HISTORIC AND DESIGN REVIEW COMMISSION

Agenda Item No: 15

HDRC CASE NO: 2015-104
ADDRESS: 803 E PARK AVE (Formerly 1106 E EUCLID)
LEGAL DESCRIPTION: NCB 832 BLK 6 LOT A&B
ZONING: MF33 RIO-2
CITY COUNCIL DIST.: 1
APPLICANT: Michael Garansuay
OWNER: Parklid City Homes
TYPE OF WORK: Construction of 6 townhome units
REQUEST:

LANDSCAPE PLANTING PLAN

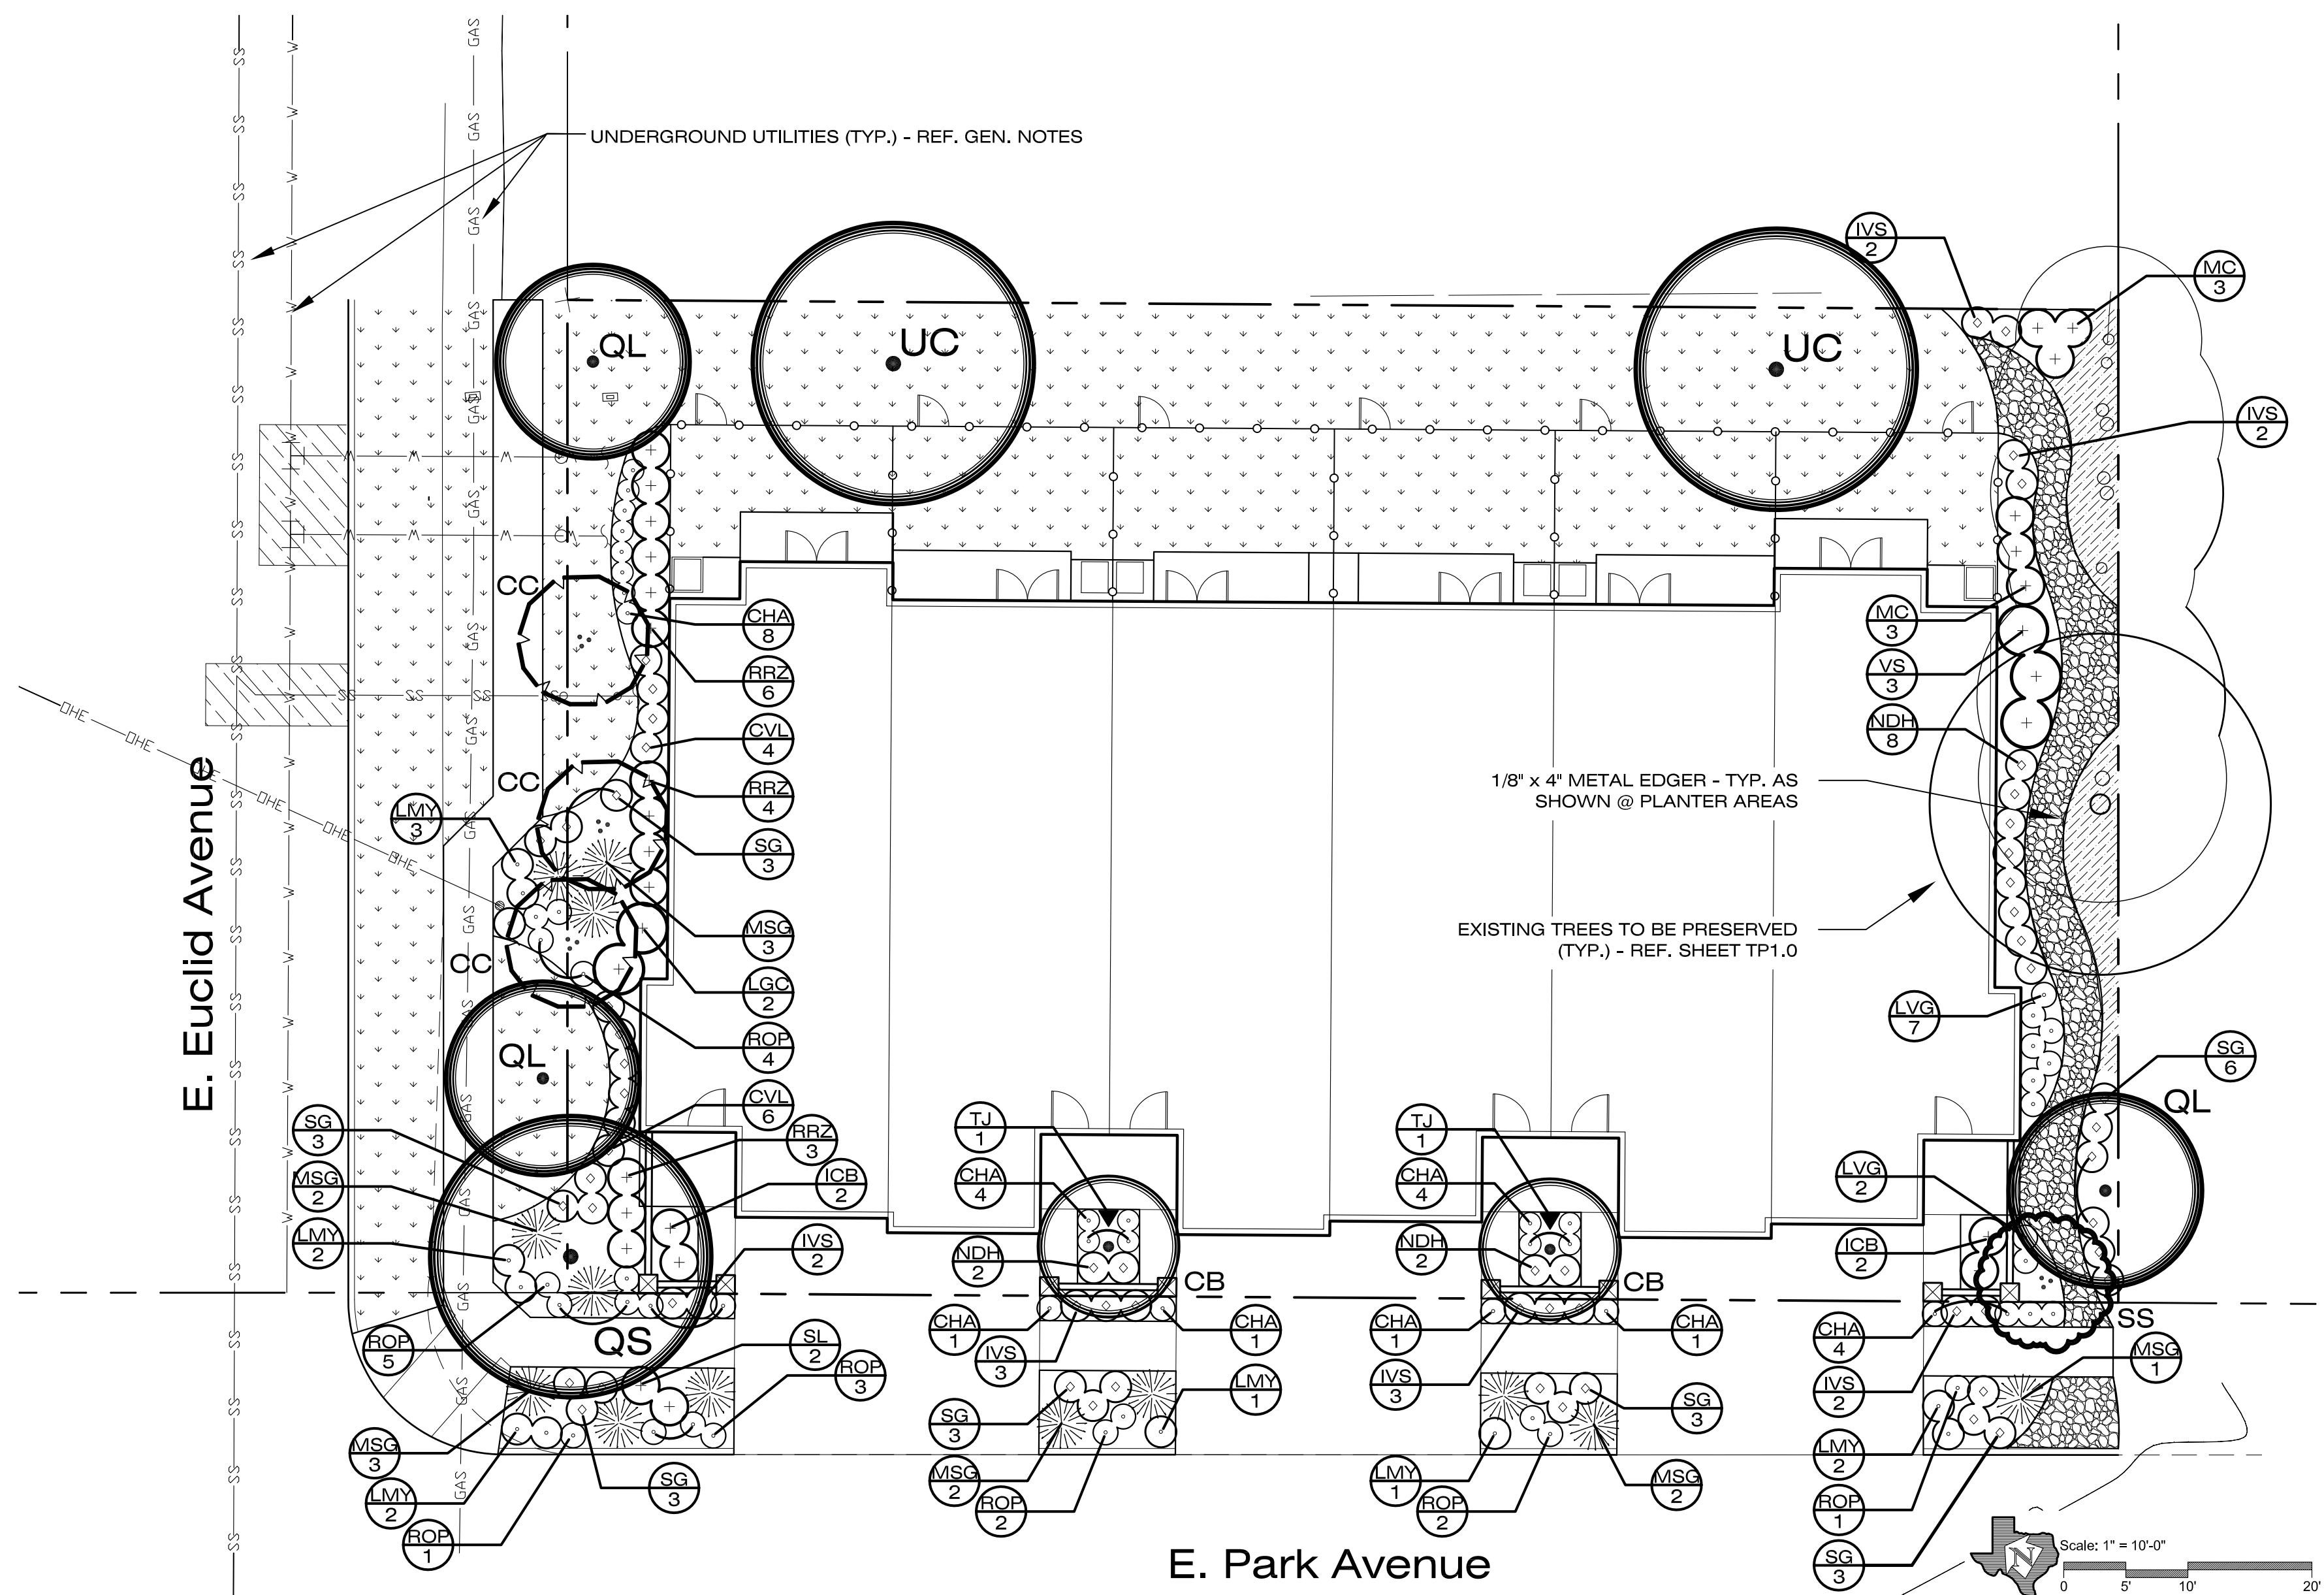
- i. The applicant has specified various native planting materials and a landscaping plan noting plantings along the public right of way at both E Park and E Euclid to buffer the proposed parking from the view of the public right of way. This is consistent with the UDC Section 35-673(e) regarding landscape design and Section 35-673(f) regarding plant materials.

SITE PLAN AND NOTES

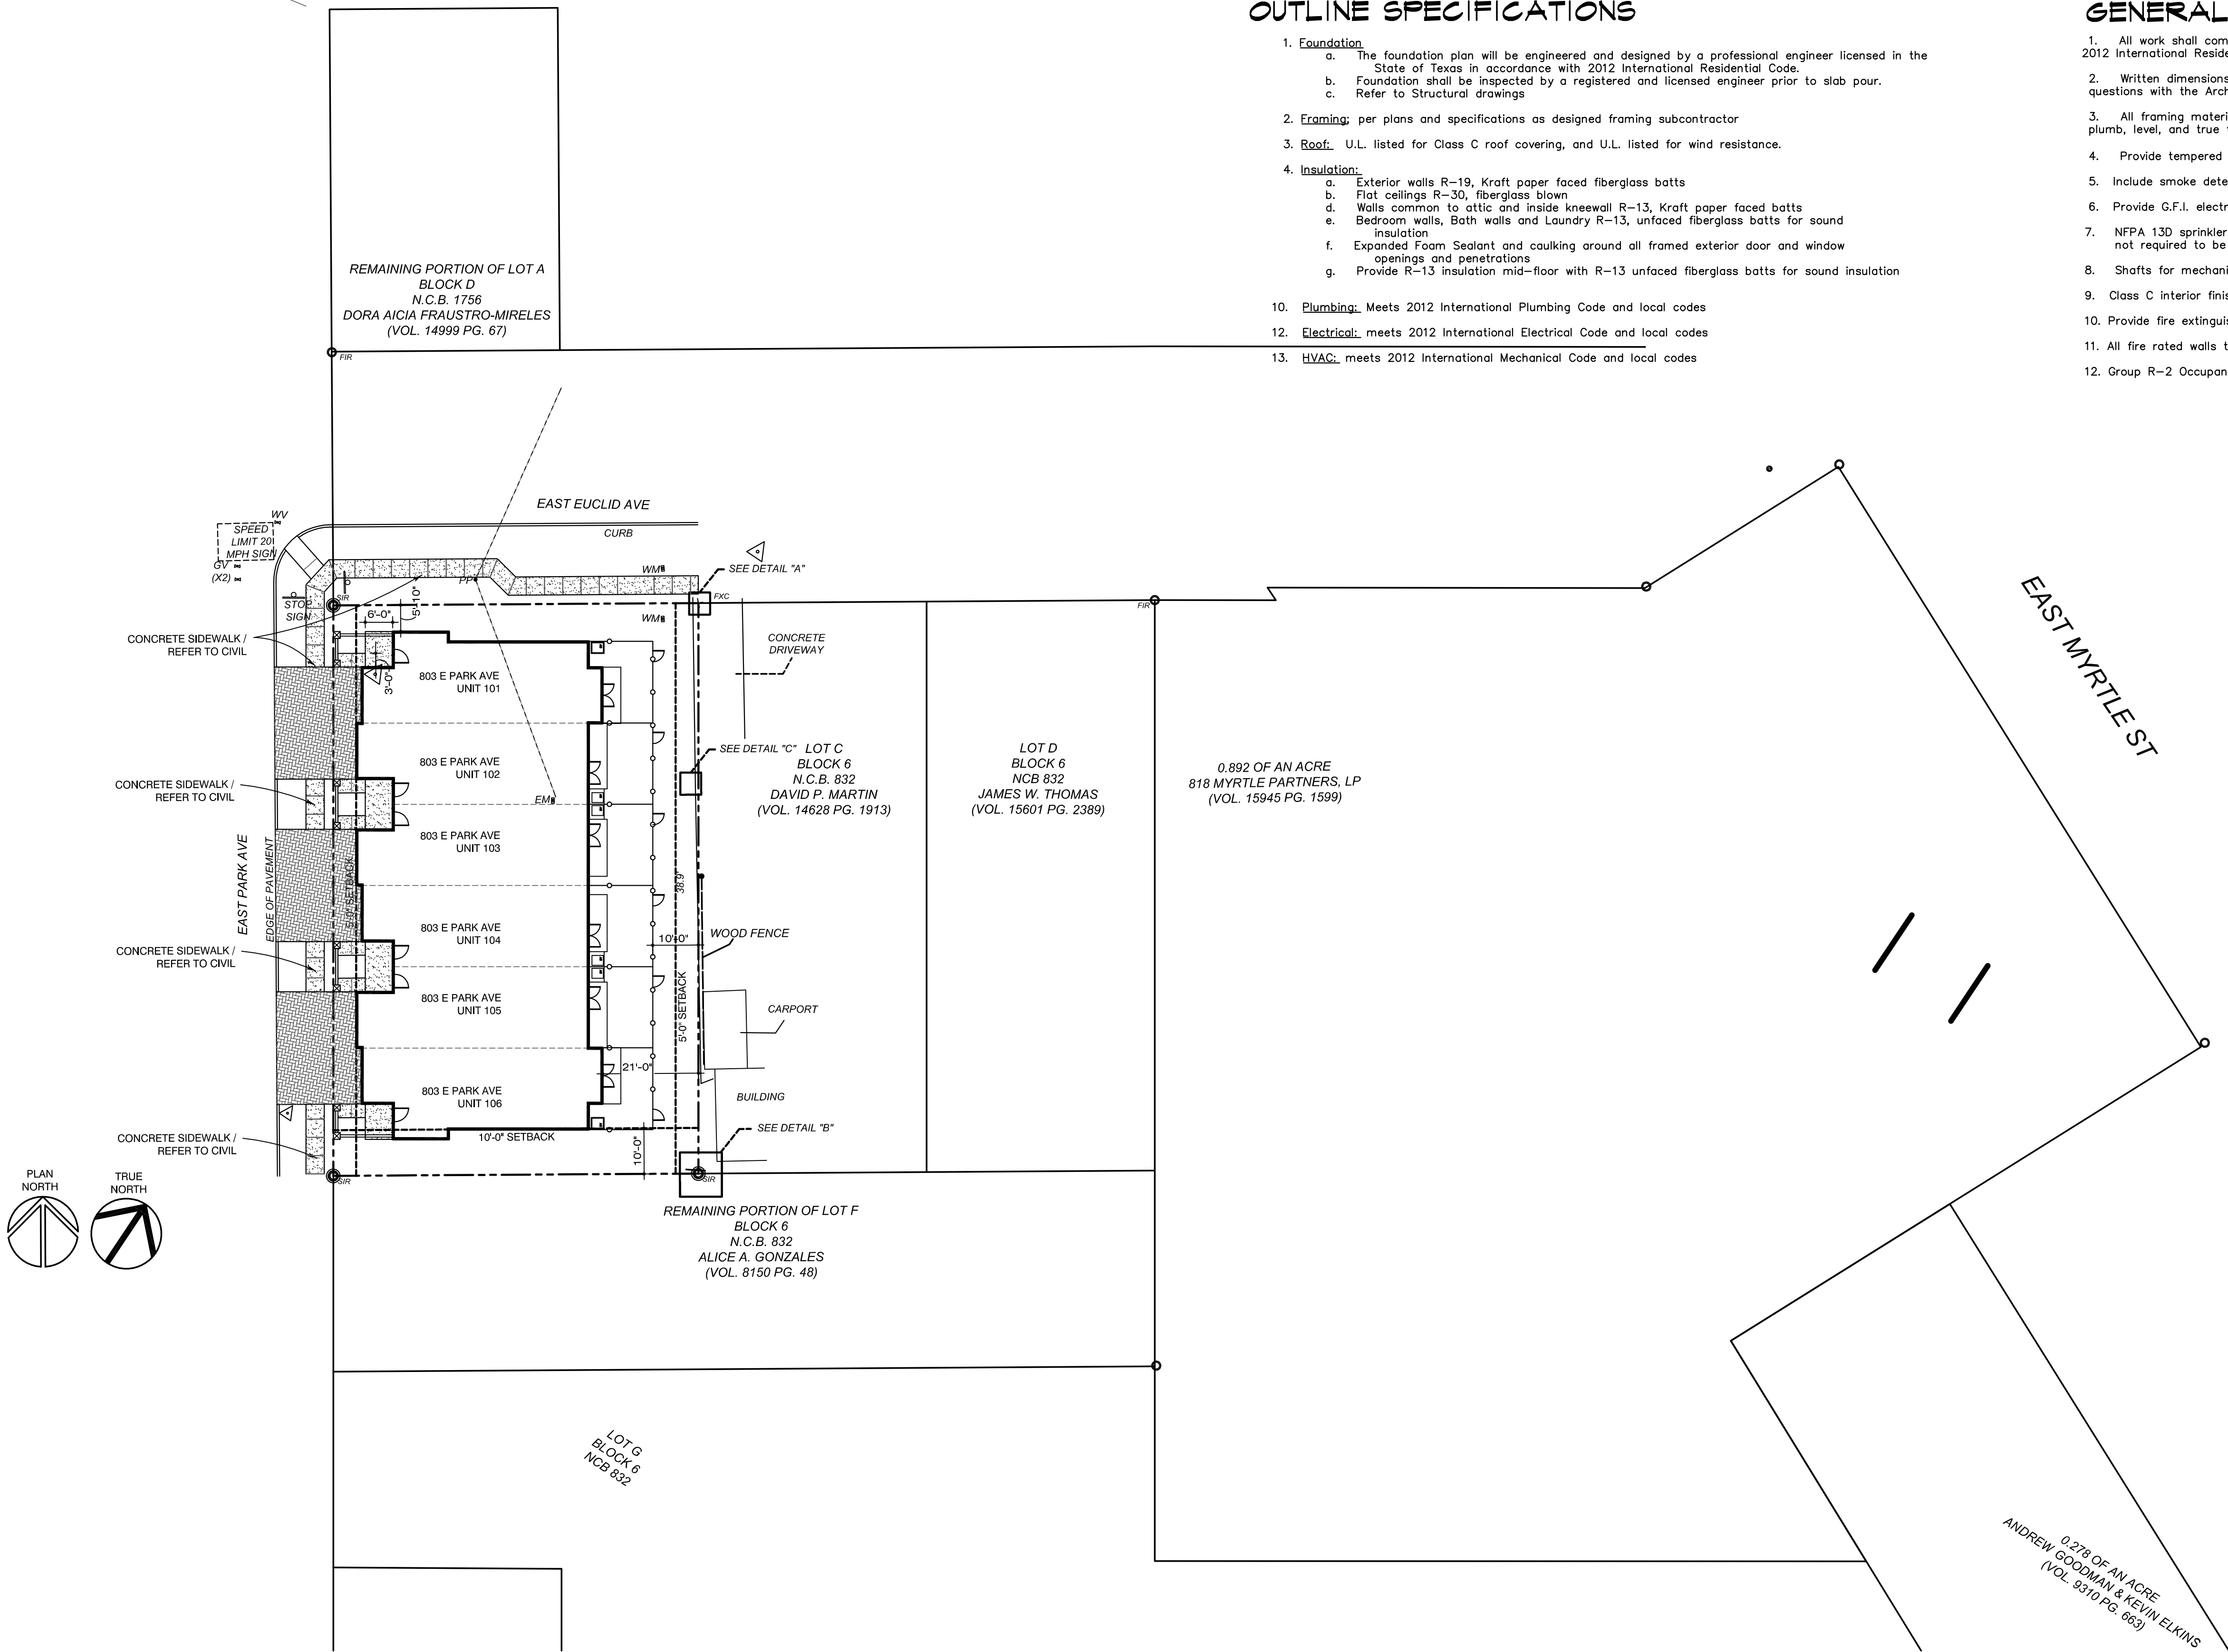
- d. According to the UDC Section 35-672 (a)(1)(A), pedestrian access shall be provided among properties to integrate neighborhoods. A sidewalk connection from one (1) side of the applicant's property to the other, parallel to the public right of way shall be provided in all river improvement overlay districts. As shown in the application documents, the applicant has proposed to provide a concrete sidewalk connection from one side of the property to the other. This is consistent with the UDC.

- f. Automobile parking in new developments should be located toward the interior of the site or to the side or rear of a building. The applicant has proposed garage parking for one automobile per unit with designated driveways. Individual driveways with street access promote parking that is not toward the interior, side or rear of a building and is not consistent with the UDC Section 35-672 (b)(2). The applicant has taken steps toward buffering the proposed driveways from the public right of way including various locations of planting materials to minimize the amount of hardscape at the site.

1 EXTERIOR ELEVATION
NEW CONSTRUCTION
1/4" = 1'

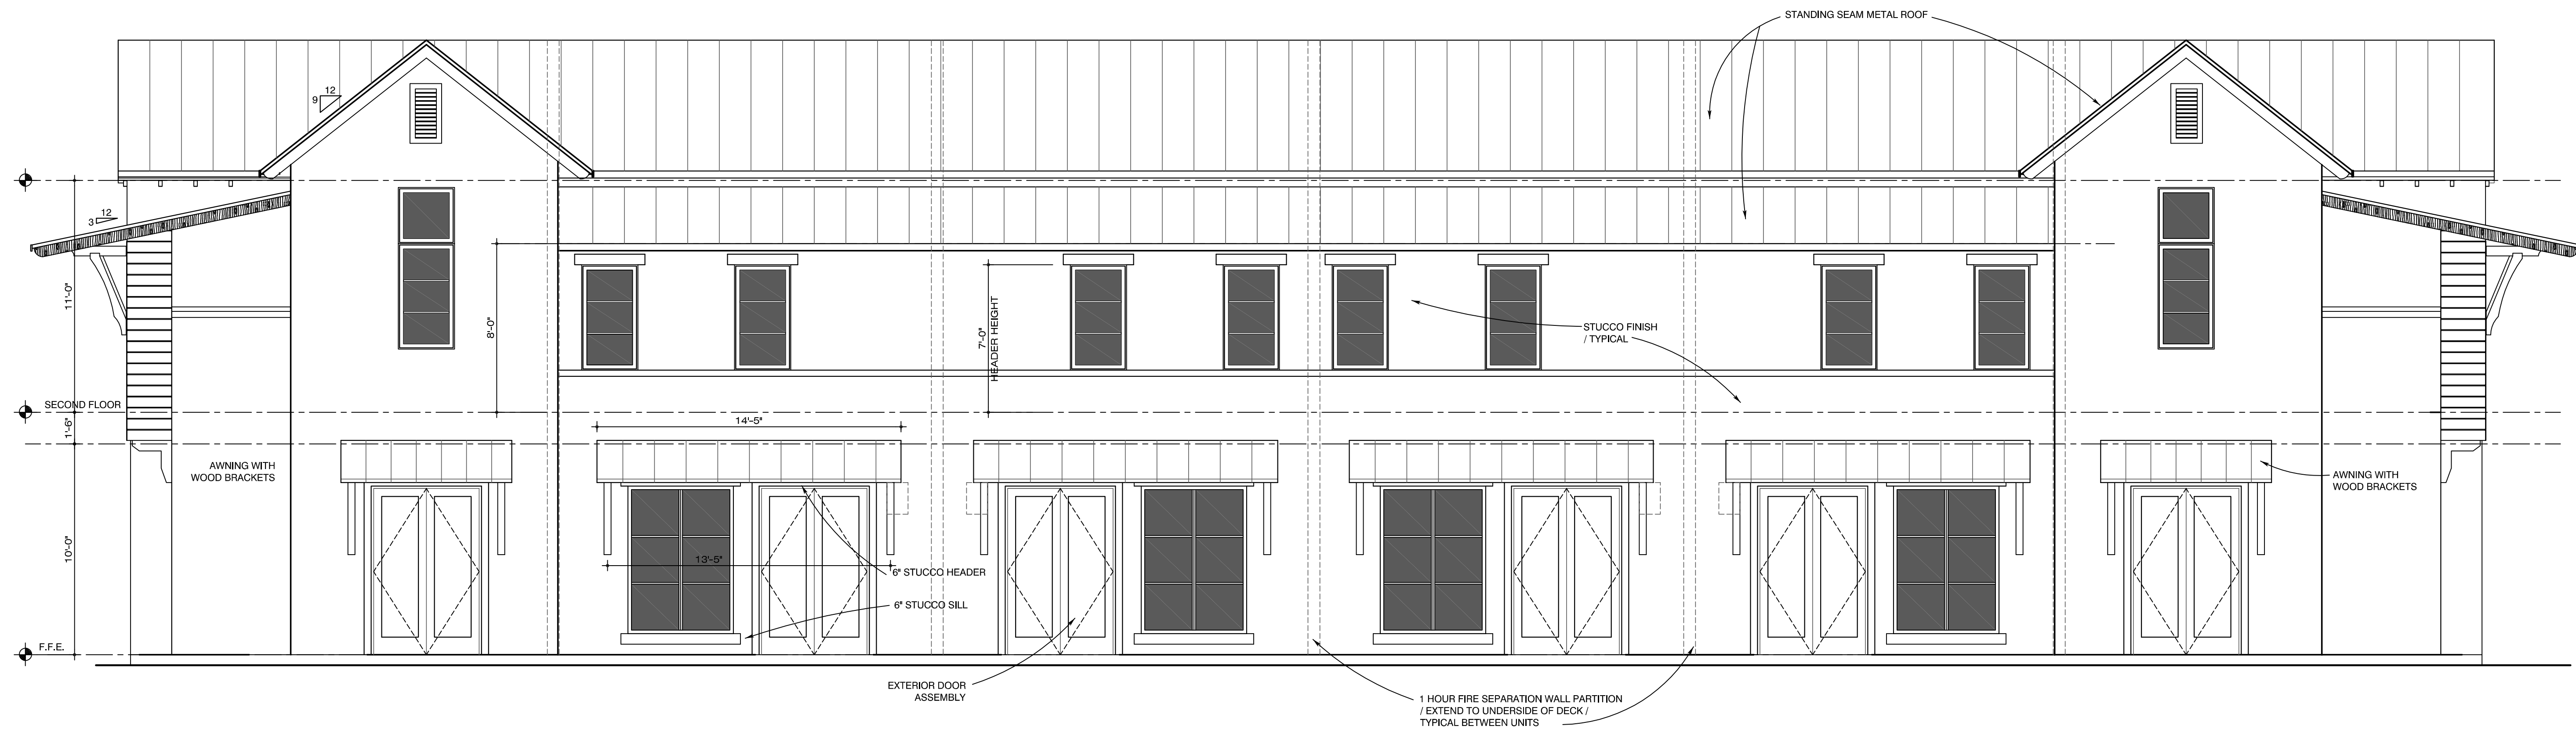
- g. Due to the unique street pattern and this lot being a corner lot, a focal point is formed, particularly when driving southeast on E Park. According to the UDC Section 35-672 (c)(1), when a property appears to be at the terminus of a street, an architectural feature is to be included in the design to provide a focal point. This can be achieved including additional height, the creation of a tower, variation in roof slope, a change in color or materials, embellished entrance areas, articulated corners or recessed or projecting balconies and entrances. The applicant has proposed a change in

- l. Per the UDC Section 35-674(b)(4) regarding scale and mass, in order to provide a human scale, buildings should be designed in a manner where their facades contain a pattern of mass to void, a distinction between upper and lower floors and a wall plain that divides the building's facades into modules that express traditional dimensions. The applicant has proposed various human scaled architectural features such as windows and doors as well awnings and façade recessions that promote a human scale. The proposed garage doors while not consistent with the UDC are modest in width and contribute to the overall façade composition which as a whole is appropriately scaled.

- o. Windows not only facilitate the separation of a building's façade, but also help provide a human scale. Per the UDC Section 35-674(e)(2), windows shall be recessed at least two (2) inches within solid walls, should relate in design and scale to the space behind them, shall be used in hierarchy to articulate important places on the façade and shall be grouped to establish rhythm. The applicant has met these requirements.
